SUBJECT: Contract Number W912P8-09-D-0046 0008, WBV-14c.2 - Westwego to Harvey Canal, Hurricane Storm Damage Risk Reduction System, New Westwego P.S. to Orleans Village, Phase 2, First Lift Levee and Floodwalls at Westminster Pumping Station, Jefferson Parish, LA

AMENDMENT OF SOLICITATION/MODIFICATION OF CONTRACT

CO-001 Government Furnished Sheet Piling

Contract W912P8-09-D-0046 0008, WBV-14c.2 - Westwego to Harvey Canal, Hurricane Storm Damage Risk Reduction System, New Westwego P.S. to Orleans Village, Phase 2, First Lift Levee and Floodwalls at Westminster Pumping Station, Jefferson Parish, LA is hereby modified to remove approximately 2,346 SF of Contractor Furnished PZ-27 Sheet Piling and replace with 2,520 SF of Government Furnished PZ-27 Sheet Piling.

SHEET IDENTIFICATION
C-11

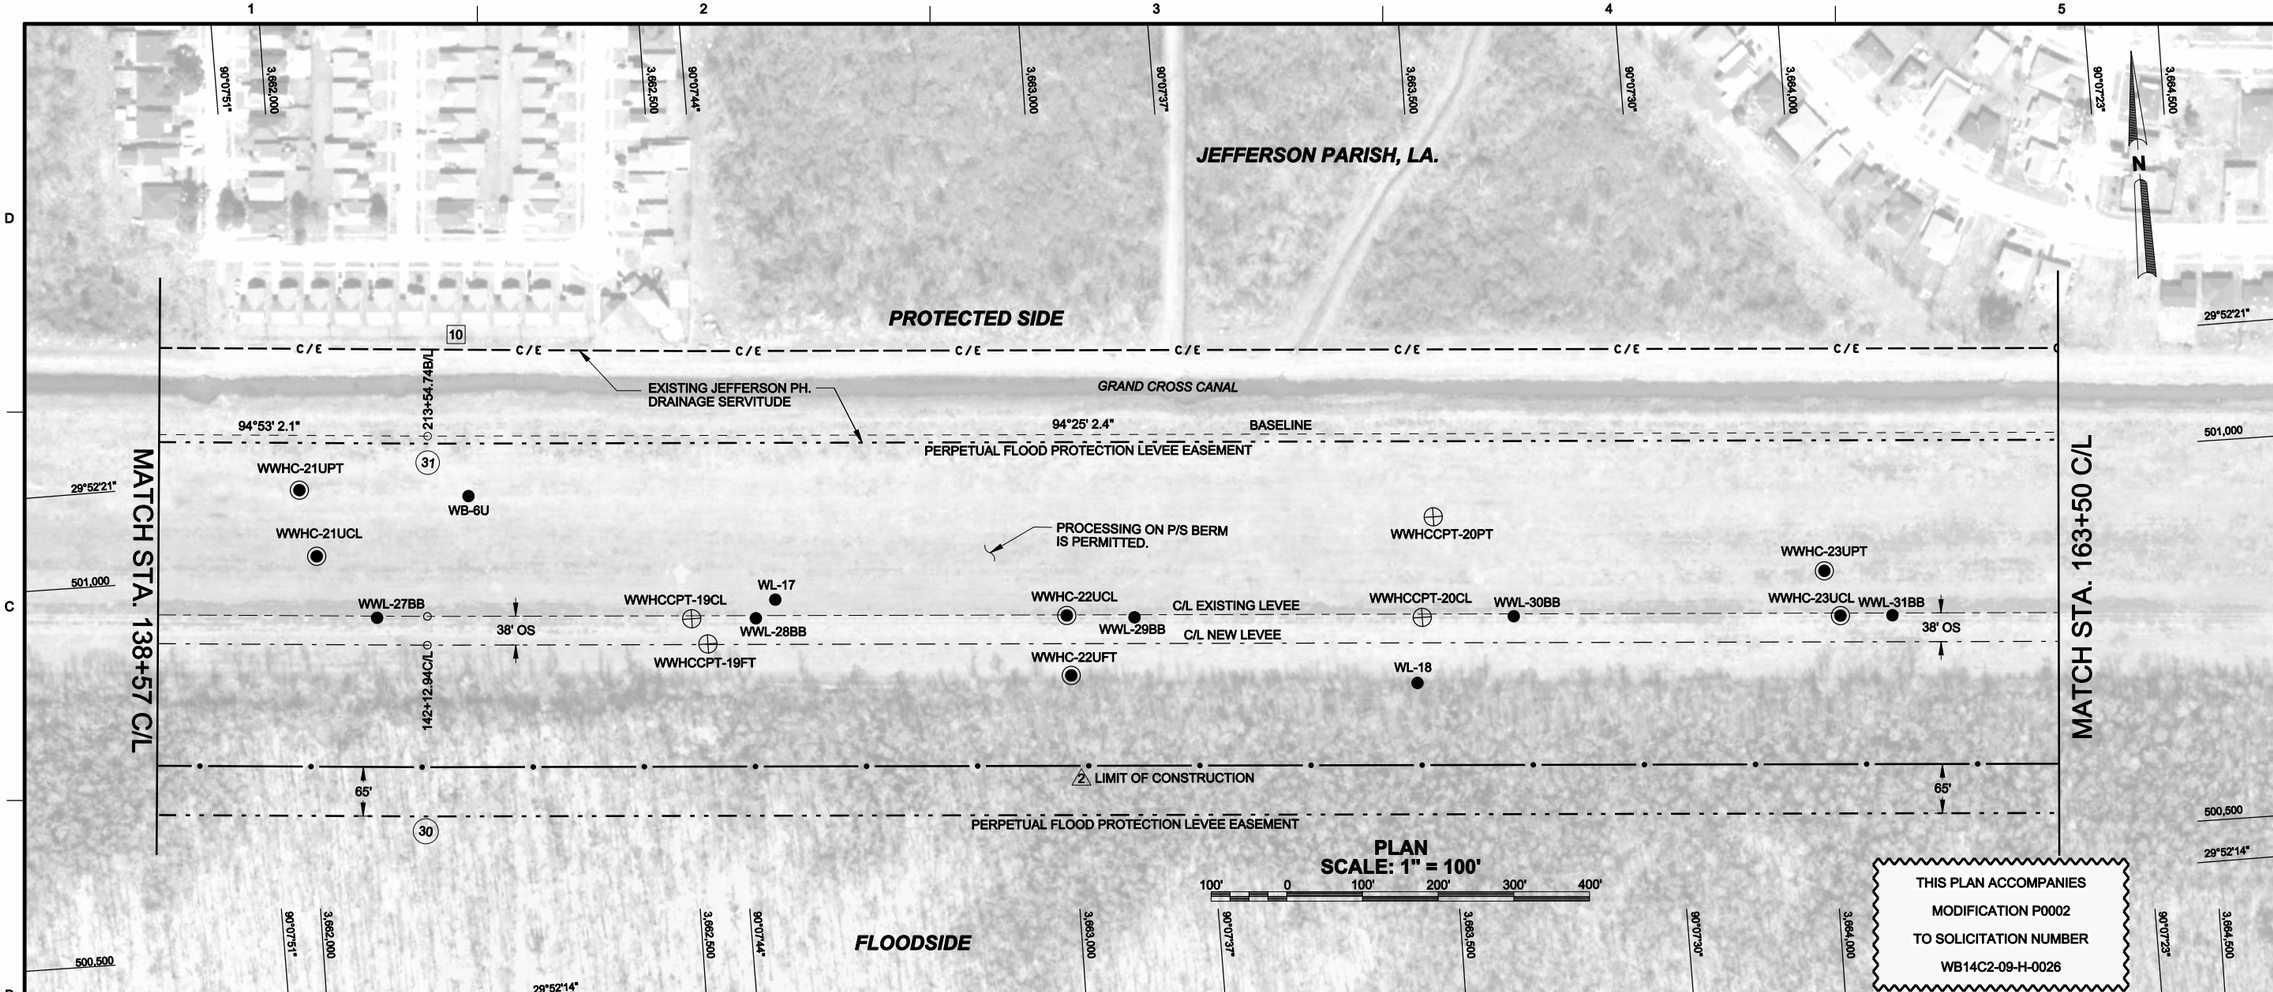
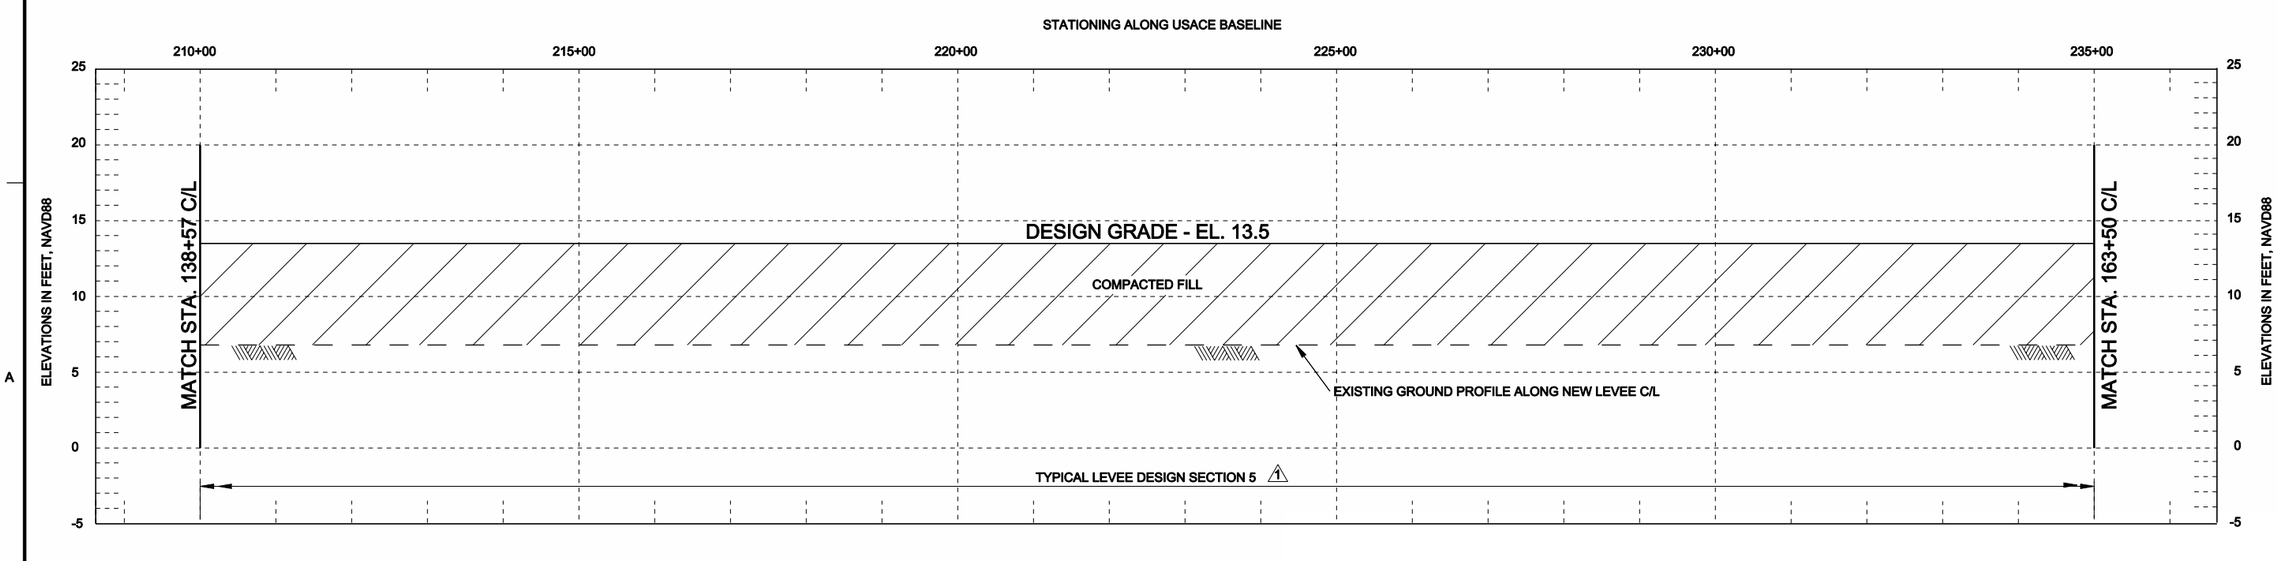
MARK	DESCRIPTION	DATE	APPR.
2	MOD. # P0002 - ADDED FLOOD SIDE LIMIT OF CONSTRUCTION.	04/05/11	B.J.L.
1	MOD. # P0001 - REVISED TYPICAL SECTION IN PROFILE.	03/15/11	B.J.L.

SHEET IDENTIFICATION
C-12

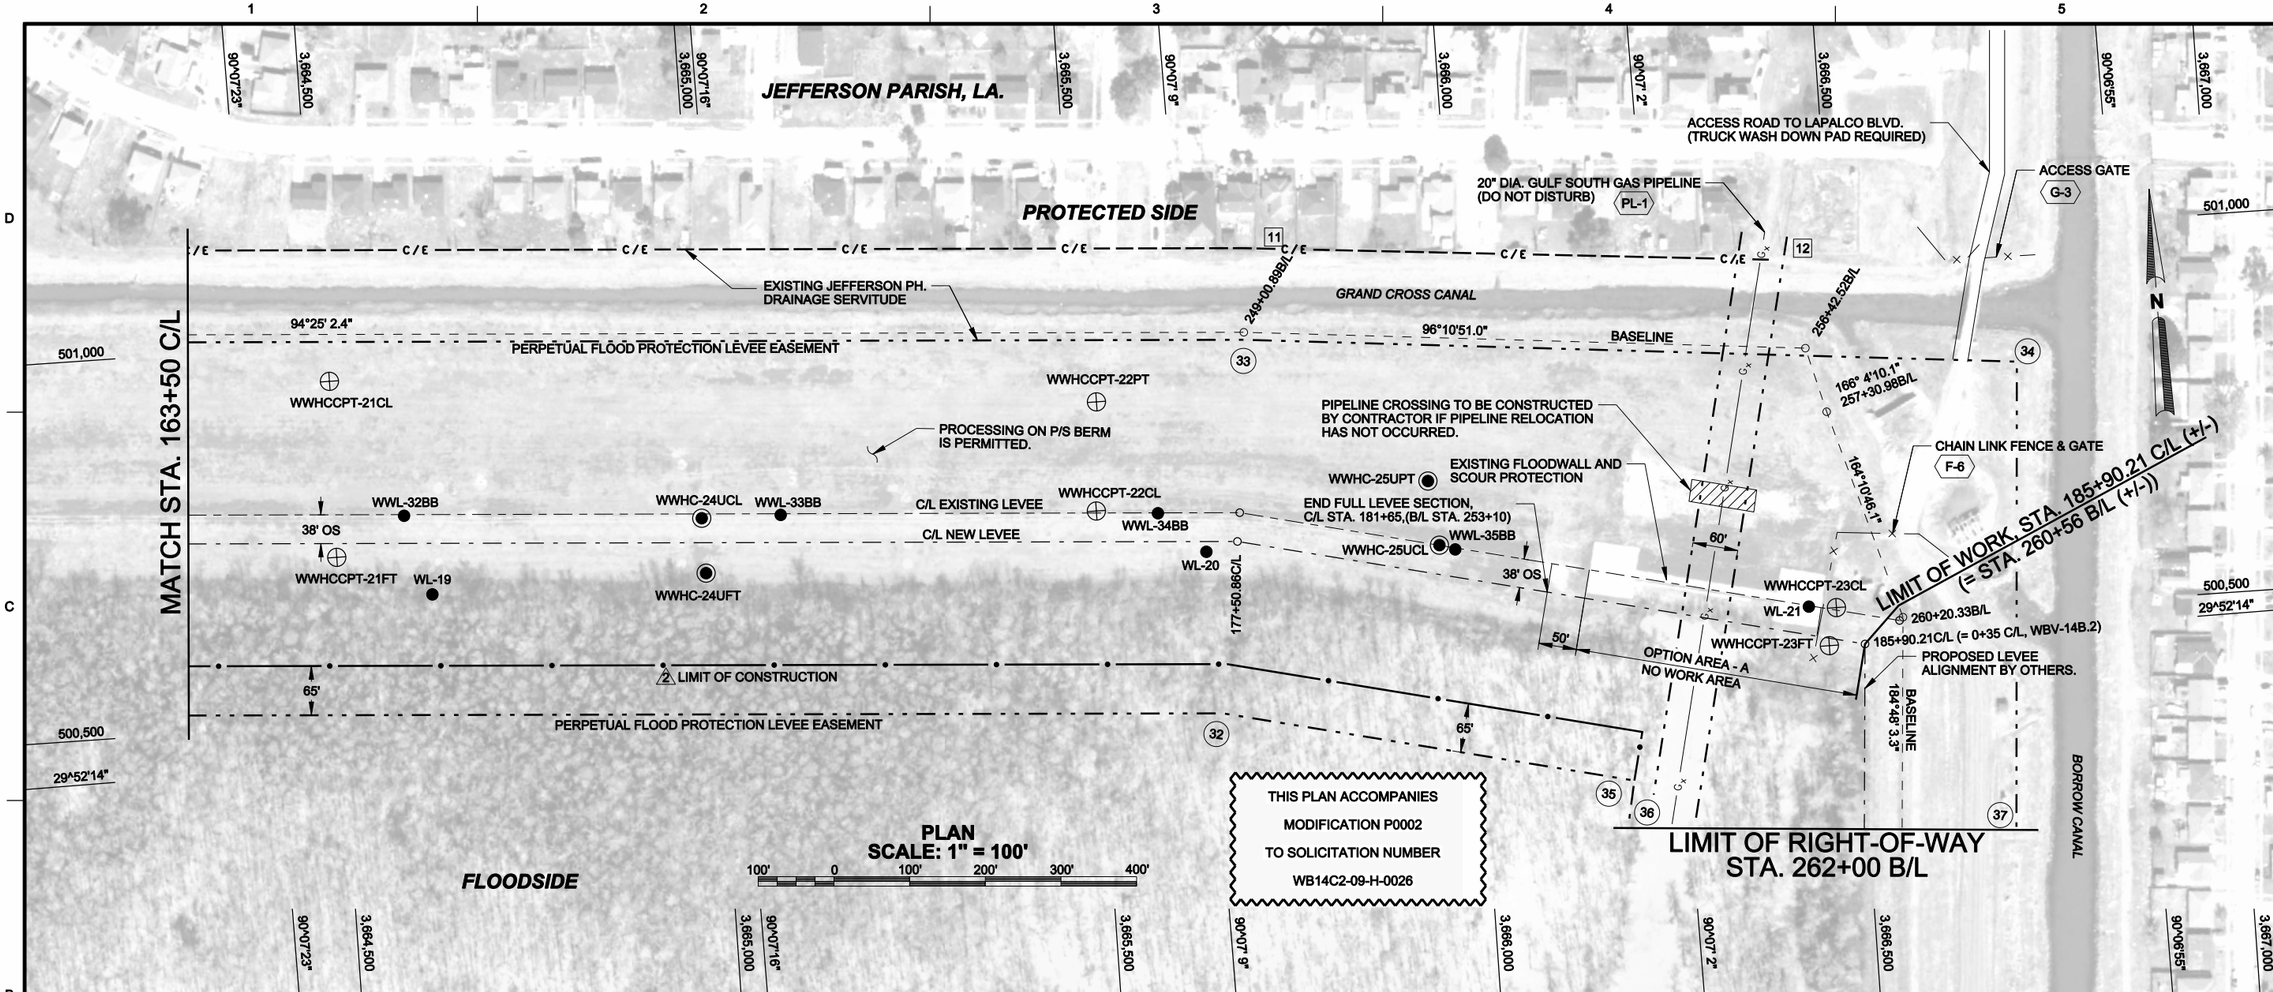
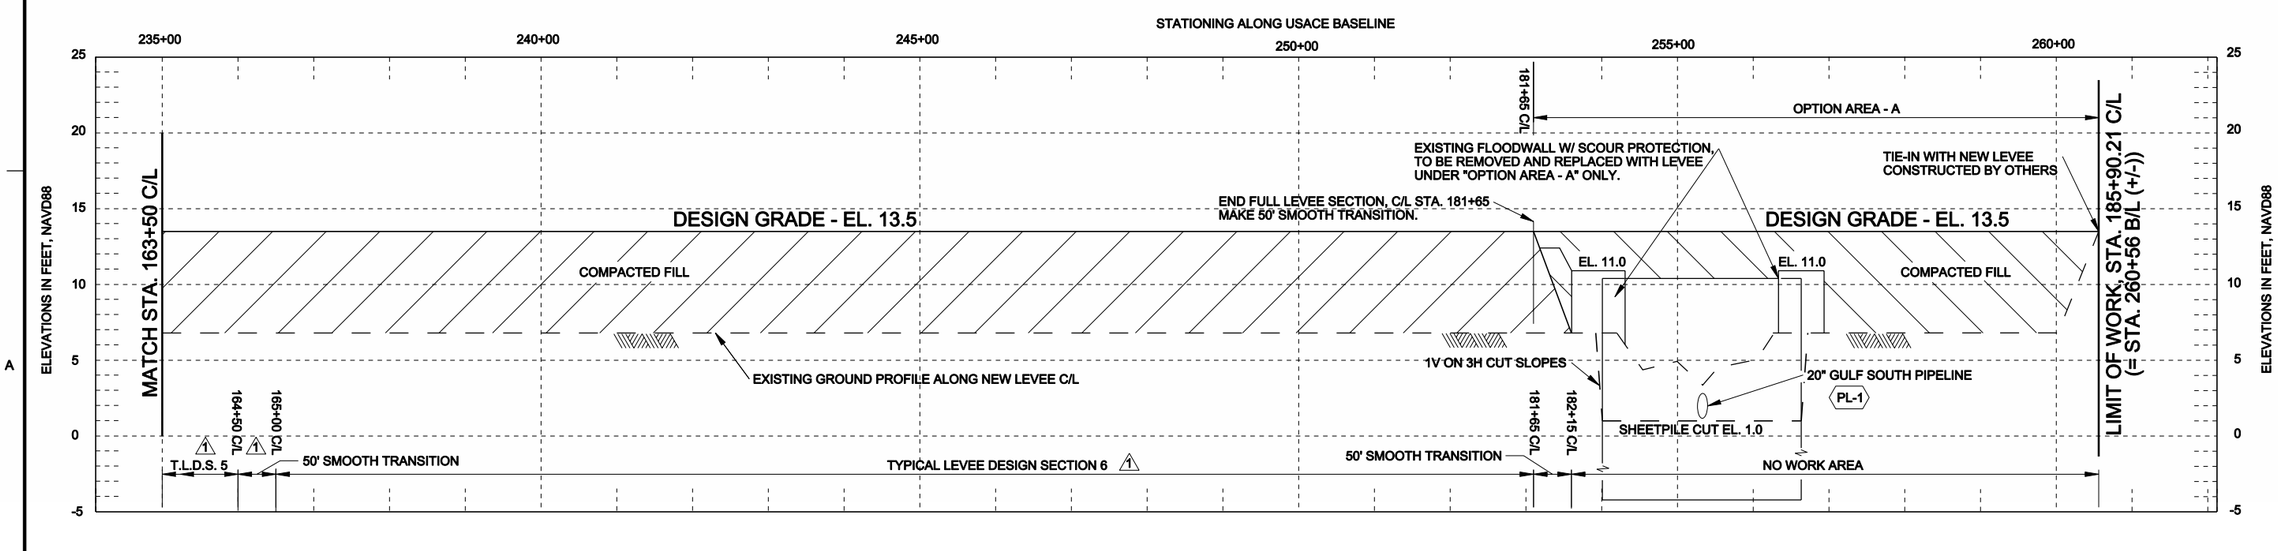
MARK	DESCRIPTION	DATE	APPR.
2	MOD. # P0002 - ADDED FLOOD SIDE LIMIT OF CONSTRUCTION.	04/05/11	B.J.L
1	MOD. # P0001 - REVISED TYPICAL SECTIONS & LIMITS IN PROFILE.	03/15/11	B.J.L

SHEET IDENTIFICATION
C-04

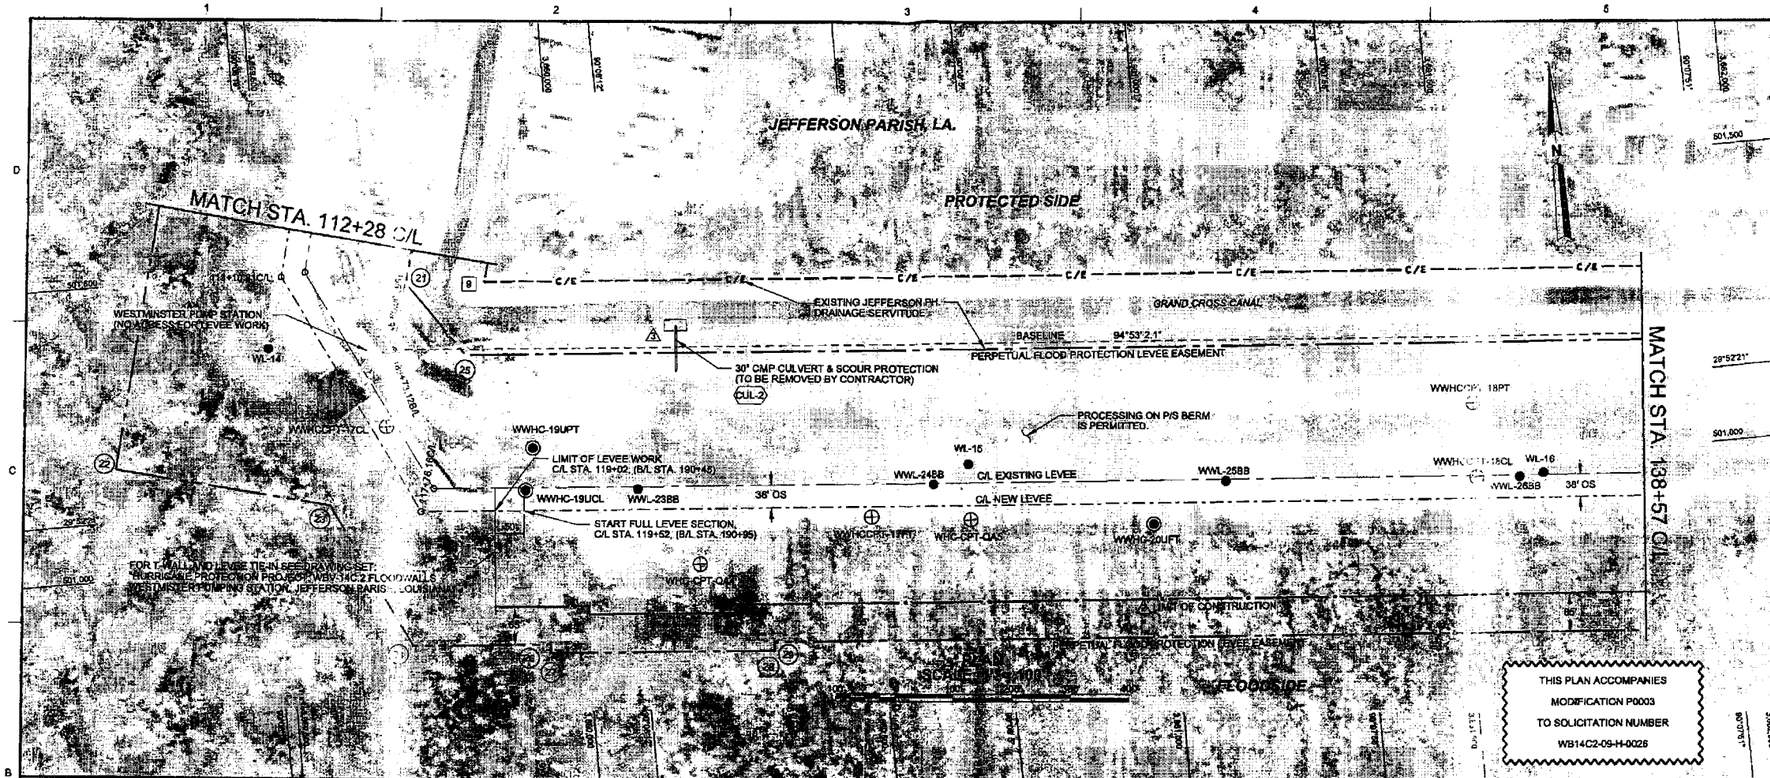
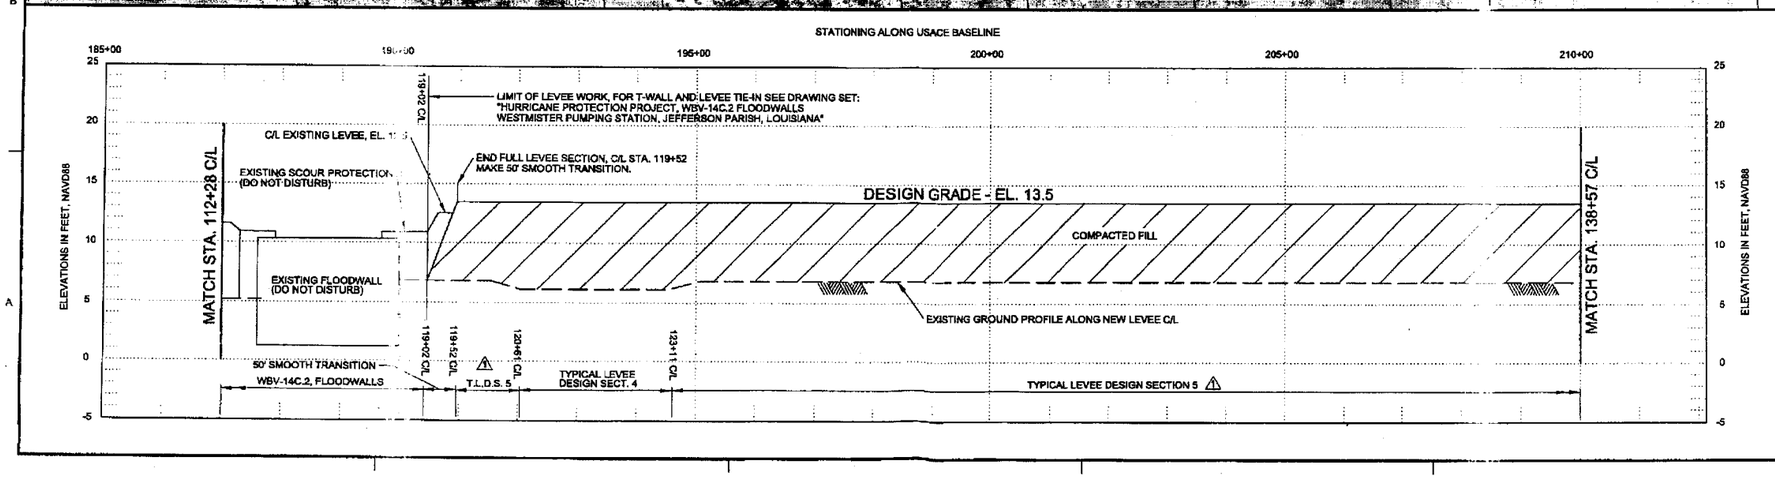
MARK	DESCRIPTION	DATE	APPR.
3	MOD# P0003 - ADDED FACILITY AT B/L STA. 193+54(C/L) TO PLANE	04/05/11	B.J.L.
2	PART OF MOD# P0003 - ADDED FLOOD SIDE	04/05/11	B.J.L.
1	MOD# P0001 - REVISED TYPICAL		
	BIS(TOP) LIMITS IN PROFILE.	03/15/11	B.J.L.
